DESIGN MEMORANDUM NO. 4-06

SUBJECT: ADA Compliance on Sidewalks, Curb Ramps, and Driveway Access

Three Standard Drawings (ERPM150, ERPM152, & ERPM170) have been modified to strengthen their compliance with the Federal Americans with Disabilities Act (ADA) and *Americans with Disabilities Act Accessibility Guidelines for Buildings and Facilities* (ADAAG). Sidewalks, curb ramps, and driveway access shall be designed, constructed, operated and maintained so that all pedestrians, including people with disabilities, can travel safely and independently.

COUNTY OF		ITEM NO.	SHEET NO.
KENTUCKY DEPARTMENT OF HIGHWAYS			
CONCRETE ENTRANCE PAVEMENT AND SIDEWALK			
APPROVED		12-07-06	DATE
BY			
KENTUCKY DEPARTMENT OF HIGHWAYS DESIGN

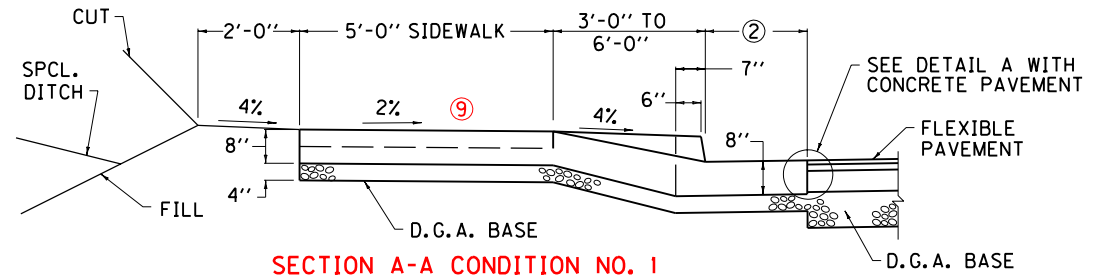
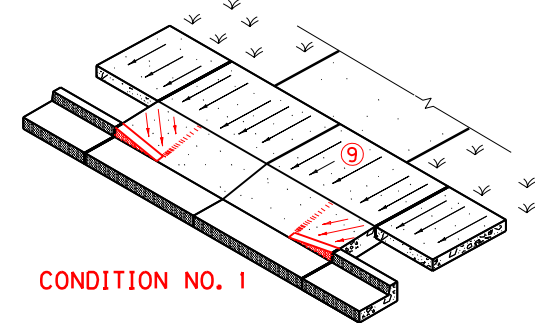
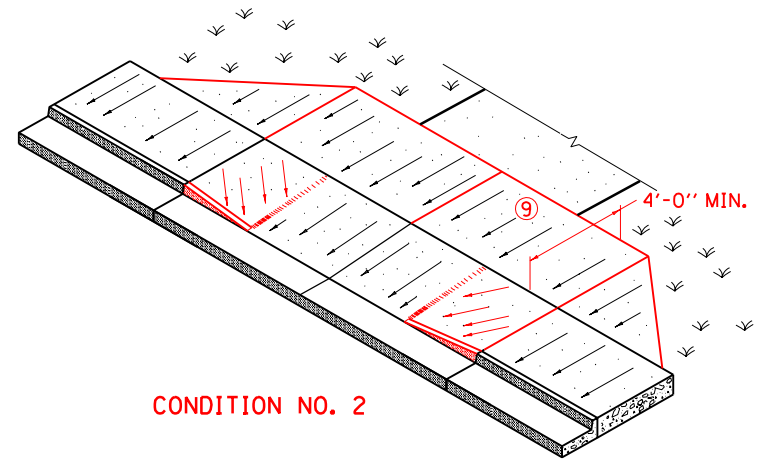
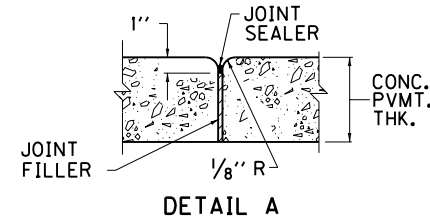
Where a driveway crosses a sidewalk, the driveway must conform in width, cross slope, and grade to the design requirements for sidewalks in order to maintain accessibility for pedestrians with disabilities. At least 4 ft of flat sidewalk area is required at the top of a sloped driveway to accommodate wheelchair use. In some cases, it may be necessary to bend the sidewalk around the back of the driveway to achieve a level surface of 4 ft. See the Standard Drawing for details.

- ⑨ 2% CROSS SLOPE MAXIMUM ON SIDEWALK. IF CONDITIONS WARRANT, SIDEWALK MAY  
BE SLOPED 2% AWAY FROM ROADWAY.
10. SIDEWALKS SHOULD BE DESIGNED WITH A MAX. GRADE OF FIVE PERCENT. WHERE A  
SIDEWALK RUNS ALONG A STEEP ROADWAY, THE SIDEWALK GRADE MAY EXCEED FIVE  
PERCENT IF IT FOLLOWS THE GRADE OF THE ROADWAY.

- ⑪ ANY DRIVEWAY 24' OR GREATER REQUIRES ADA SIDEWALK TREATMENTS WITH DETECTABLE  
WARNINGS WHICH WILL BE INCIDENTAL TO THE ENTRANCE CONSTRUCTION.

SIDEWALK  
RAMPS

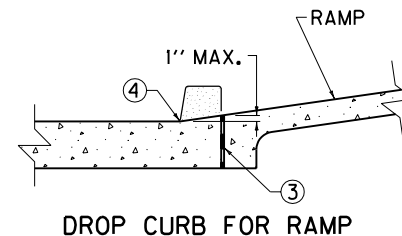
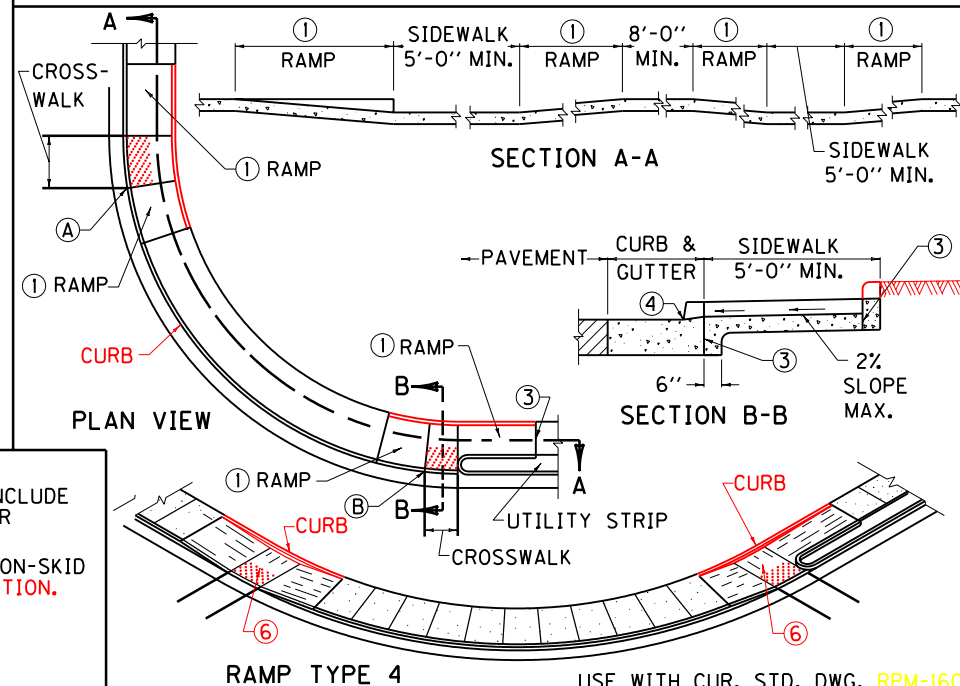
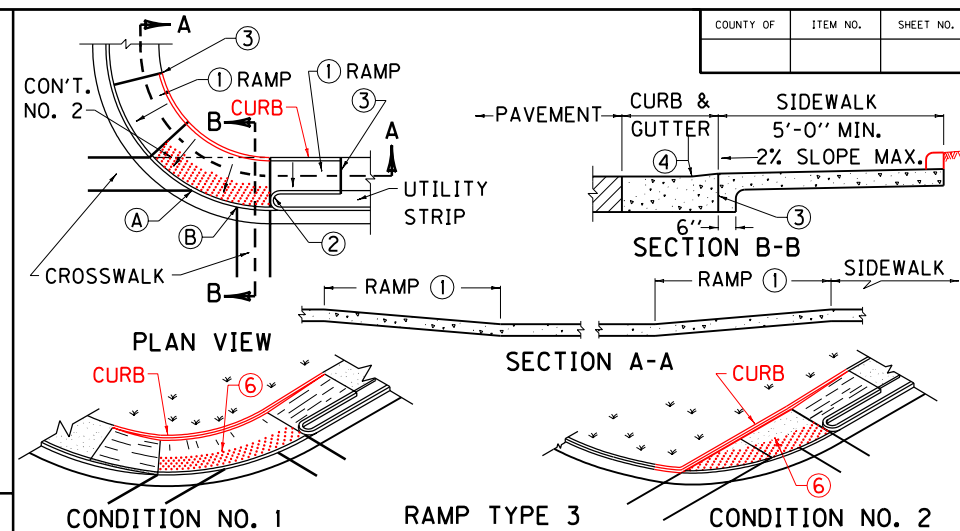
Curb ramps are required at all pedestrian crossings, including midblock crossings as well as at intersections. When locating curb ramps, designers must consider the position of drainage facilities and utilities such as power poles, fire hydrants, street lights, and traffic signals. Ramps shall have level landings (4 foot square minimum) at bottom and top of each ramp.

⑥ LANDINGS WILL PROVIDE A LEVEL AREA (LESS THAN 2% GRADE OR CROSS SLOPE) AT APPROXIMATE STREET ELEVATION. A 4 FOOT SQUARE LEVEL LANDING IS THE REQUIRED MINIMUM.
